# Access Compliance Report

## Public Rights-of-Way

Intersection ID: 9328	Main Street: PLAZA_LN	Cross Street: THE_PLAZA	Location:	N
ADA ID: CA1741B4E2CB	Ramp Type: BlendTrans1	Initial Pass/Fail: Fail	Overall Compliance: No	Severity Score: 10

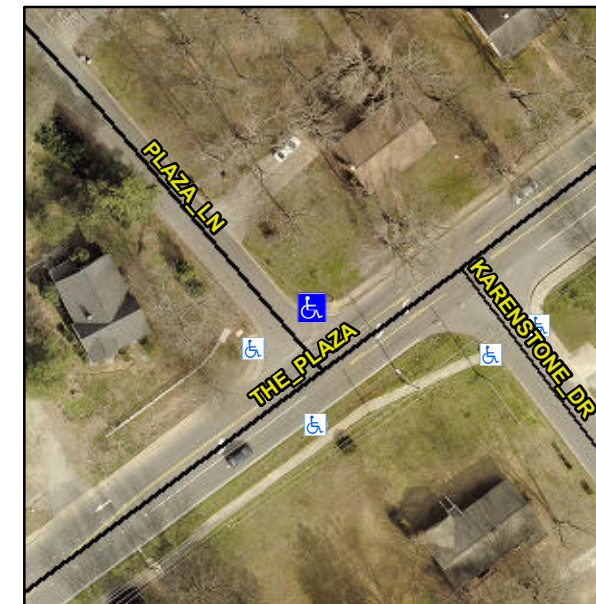
**NO LT SW**

**Not Found, R304.5.1, R304.5.3**

**Remove & Replace Curb Ramp With Two New Directional Ramps or Equivalent.**
